Description of Revisions: *This bulletin replaces the version dated December 2010. A new turbo outlet pipe support bracket has been added to [Table 1](#), and the replacement procedure has been updated to include the new bracket.*

Table 1, EPA07 Exhaust Bellows Replacement Parts

Fig. 1, Vertical Measurement

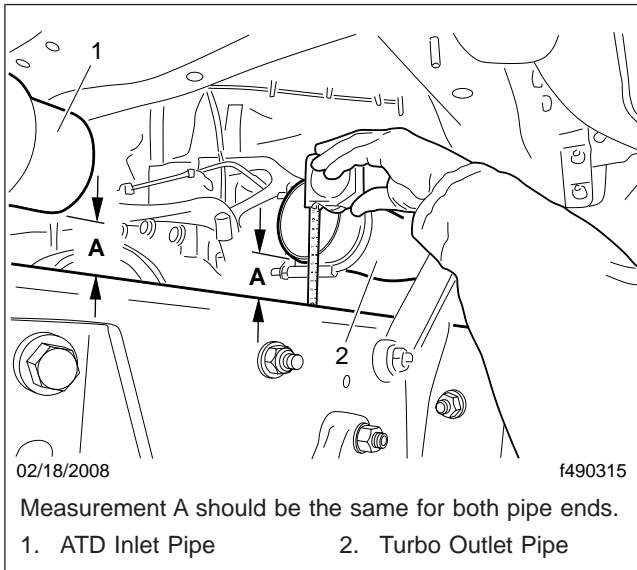
- 3.3 Measure the vertical distance between the pipe ends and the frame rail. See [Fig. 1](#). This measurement must be the same for both pipe ends.
 - 3.4 Measure the horizontal distance between the pipe and the frame rail. See [Fig. 2](#). This measurement must be the same for both pipe ends.

Fig. 3, Measuring Between the Pipes

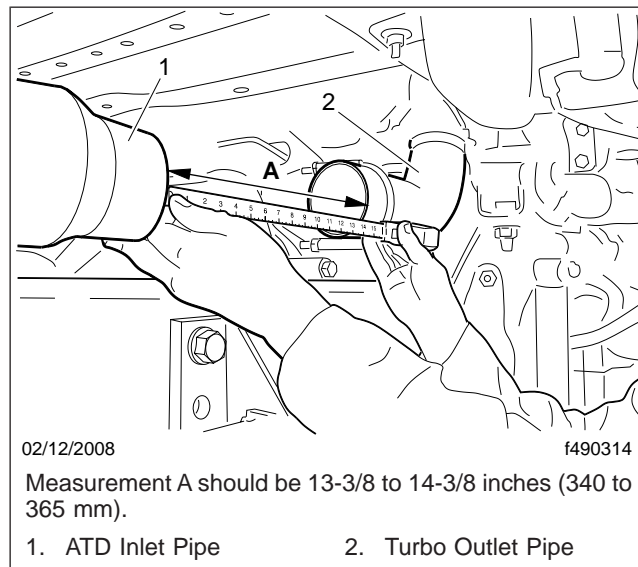
4. Once the pipes are aligned and concentric, measure the distance between the ATD inlet pipe and turbo outlet pipe. See [Fig. 3](#).
The minimum distance should be 13-3/8 inches (340 mm), and the maximum should be 14-3/8 inches (365 mm). If they are too close together cut an equal amount off of each pipe to meet the minimum distance.

Fig. 4, Aft Facing Slip Clamp Installation

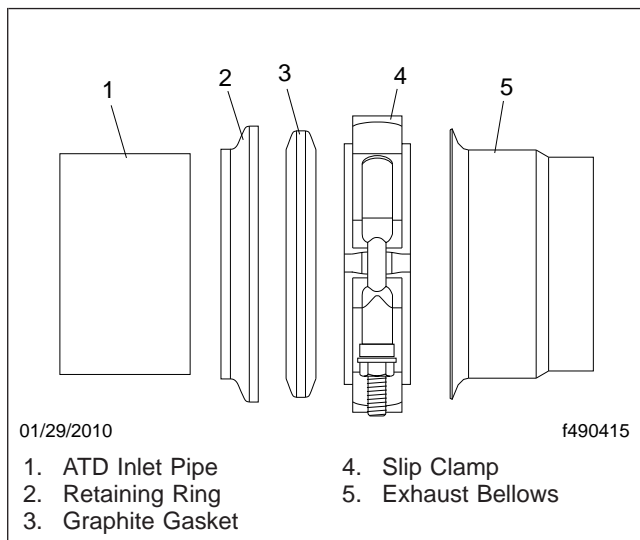
6. Once the pipes are correctly aligned and separated at the correct distance, secure the ATD inlet pipe.
7. Remove the turbo outlet pipe from the truck.
8. Slide the slip clamp, with the retaining ring and graphite gasket ring, on the ATD inlet pipe. See [Fig. 4](#) for proper installation.
9. Slide the new bellows onto the ATD inlet pipe as far as it will go. See [Fig. 5](#).

Fig. 5, EPA10 Exhaust Bellows

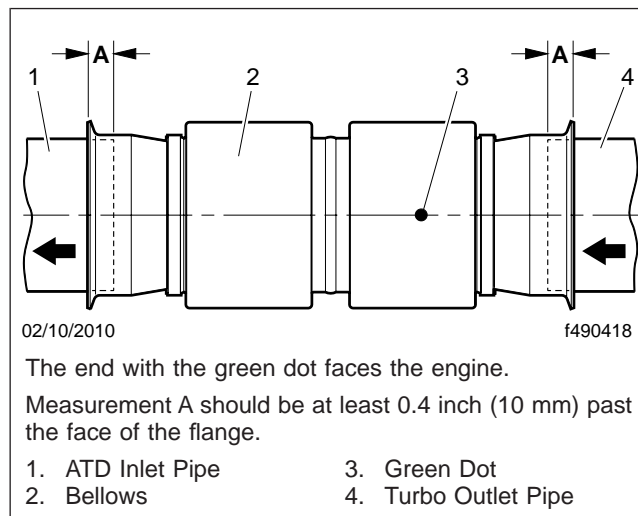
11. Slide the outlet end of the turbo outlet pipe into the bellows, and align the other end to the turbo.
12. If not already replaced, remove the old style turbo outlet pipe support bracket (04-24627-000) from the frame rail and discard it.
13. Install the new support bracket (04-29024-000). Tighten 103 lbf-ft (140 N·m).
14. Using the original clamp, secure the turbo outlet pipe to the turbo and pipe support bracket.
15. Using the yellow marks, center the bellows between the exhaust pipes. Verify that the pipe is inserted at least 7/16 inch (10 mm) past the face of the flange. See [Fig. 5](#).

Fig. 6, Forward Facing Slip Clamp Installation

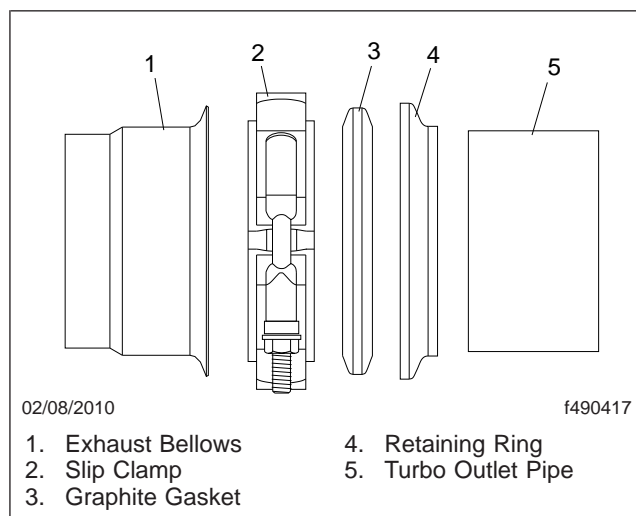
10. Install the slip clamp with the retaining ring and graphite gasket ring onto the turbo outlet pipe. See [Fig. 6](#) for proper installation.
